Docket Item # 5 & 6  
BAR CASE # 2010-0049, 0050

BAR Meeting  
May 5, 2010

**ISSUE:** Permit to Demolish/Encapsulate & Addition

**LOCATION:** 812 South Lee Street

Figure 2: Photo simulation showing proposed third floor addition.

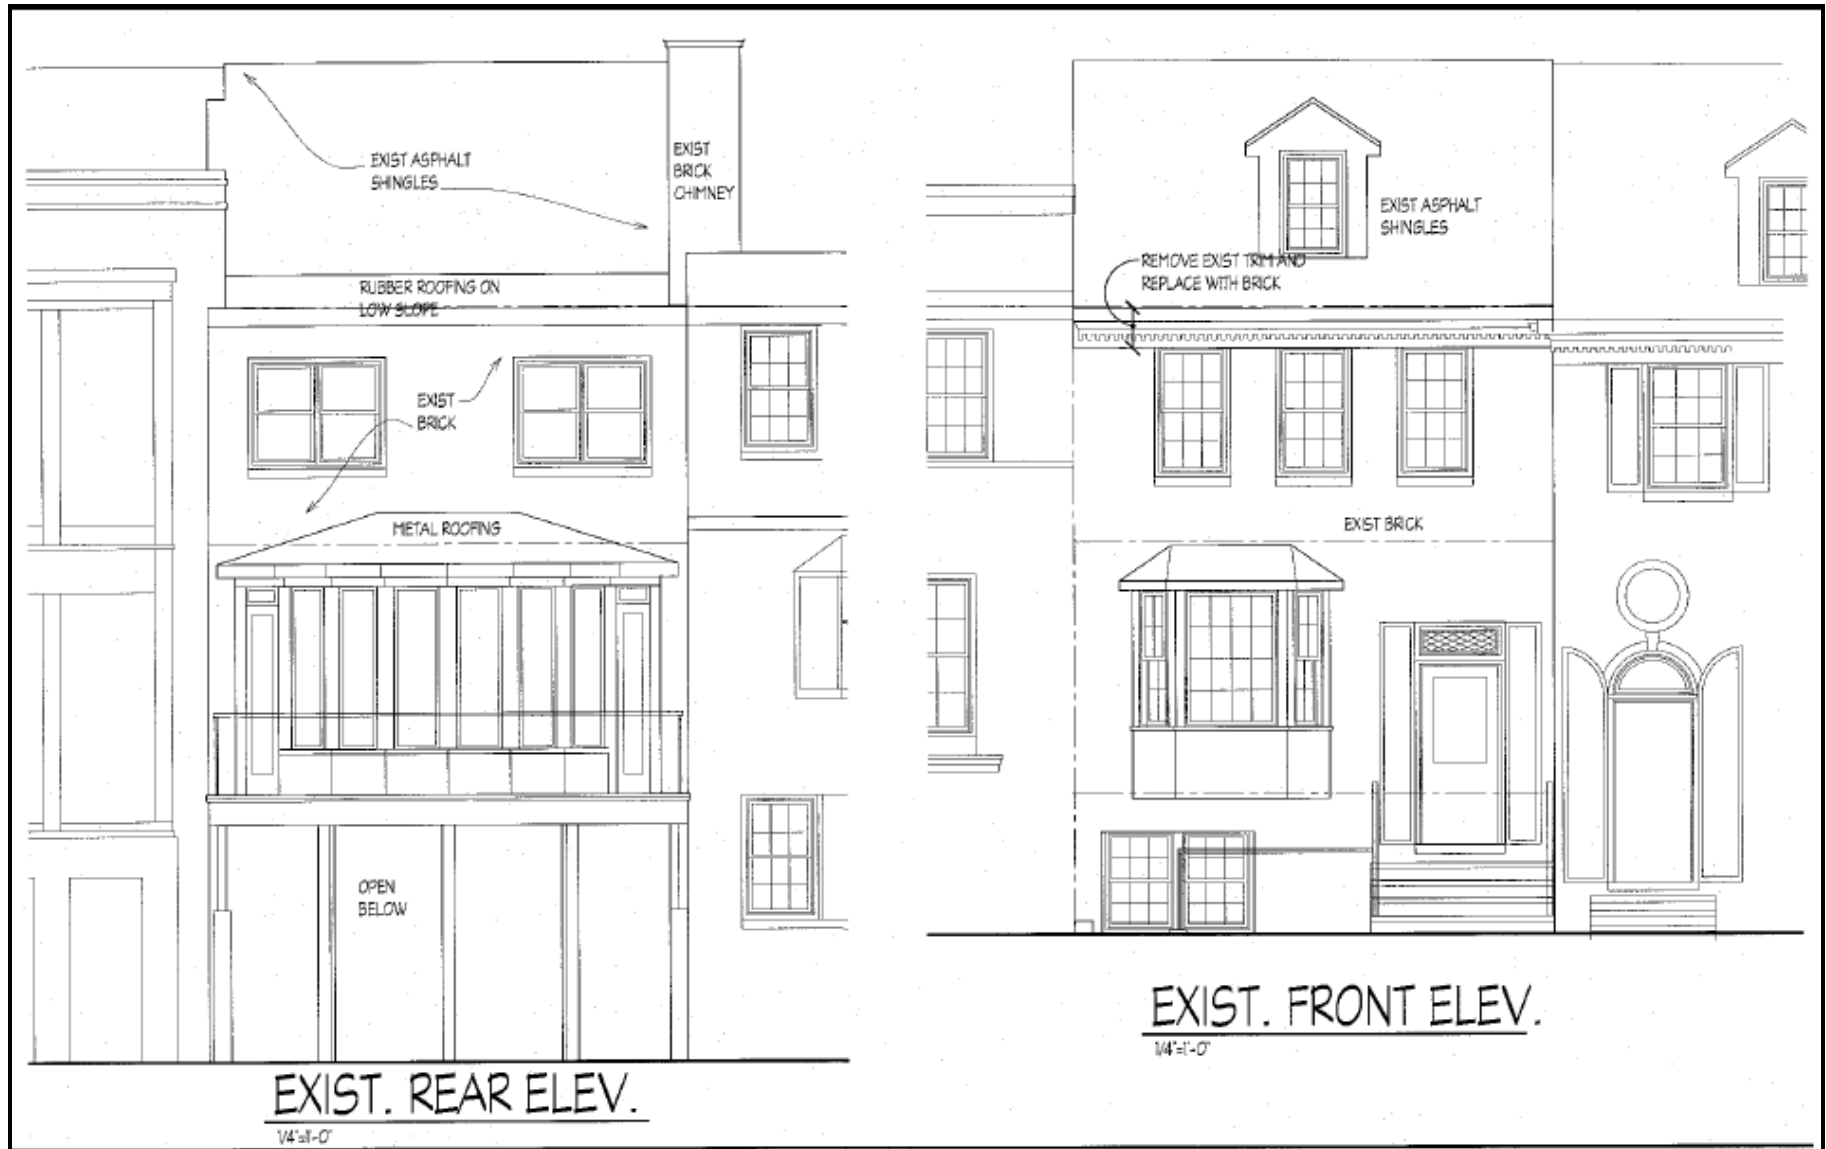
**Update:** The applicant has responded to the Board's request and significantly reduced the mass of the third floor addition. Both the height and footprint are noticeably smaller, as demonstrated in the attached photo simulation.

The ridge height of the revised third floor addition will be 1 foot 11 inches higher than the existing front gable (versus the previously proposed increase of 4 feet 8 inches), with a steeper front roof pitch. The pitch will increase from the existing 8/12 slope to an 11/12 slope. The new roof will appear as a gable roof form from the front, but the rear will have a very gradual, almost flat slope. As previously proposed, the front façade will be increased in height by approximately 2 feet 9 inches, which will be accomplished using a matching brick veneer above the second floor windows and a new HardieTrim cornice. The gutters and downspouts on the addition will be constructed of copper. As a result of the height increase, the chimney must also be raised, although less so than previously proposed. The addition will have HardiePlank siding and a black prefinished aluminum standing seam metal roof. Two skylights will be installed on the rear slope of the roof. All of the HardiTrim and HardiPlank will be painted white. Additionally, although not required by the Board, the architect reduced the footprint of the addition by pulling in the rear wall in 4 feet 6 inches to address the adjacent neighbors' concern about visibility from their rooftop deck.

Figure 5: Proposed elevations from April 21, 2010 BAR meeting.

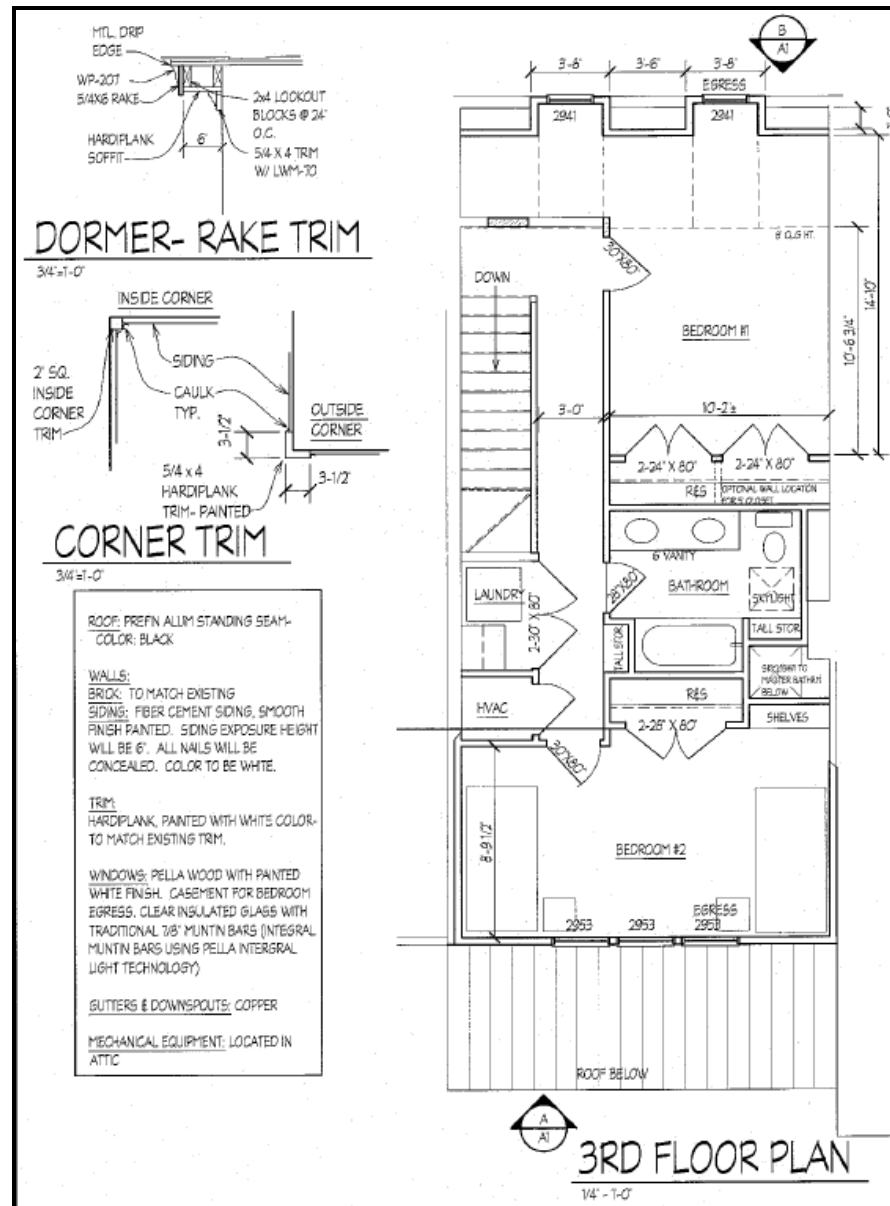
On a motion by Mr. Smealie, seconded by Mr. von Senden, the Board voted to defer the application and directed the applicant to restudy the building massing, in particular how it relates to the adjacent properties. The vote on the motion was 5-0.

**REASON:** The Board agreed with the Staff analysis and found the proposed new third floor addition too large in contrast to the adjacent townhouses.
